ARCEDGES _ Shutter Size W6000 x H6000 - 3nos
Name - Hood Cover (1250x0.9 mm)- 6500 MM L
Material - G.I.
Thk - 0.9 mm
QTY - 03 NOS

TITLE - DOOR AUTOMATION

DWG NO - NTPL- 300-PM-01

PRODUCT - MOTORIZED ROLLING SHUTTER

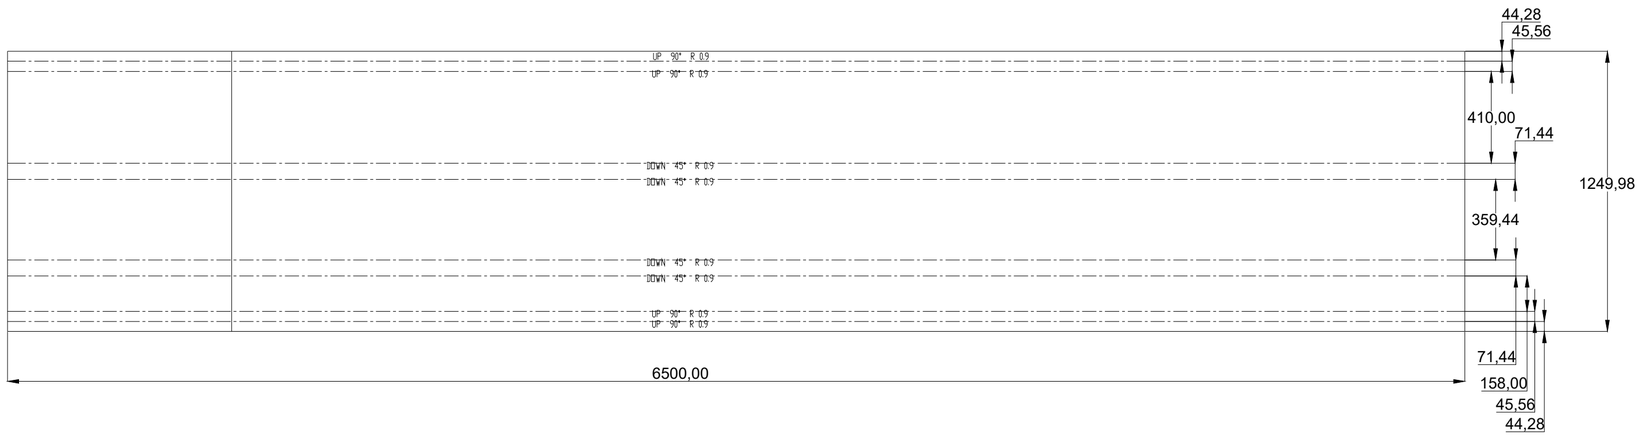
| RIVISION. | DATE |
|---|---|
| REV 01 : SLAT THICKNESS CHANGE 1MM TO 1.2MM<br>BOTTOM PLATE THICKNESS CHANGE 2.5MM TO 3.15MM<br>ANGLE STIFFENER CHANGE 35X35X3 MM TO 35X35X5 MM | 03-12-2025 |
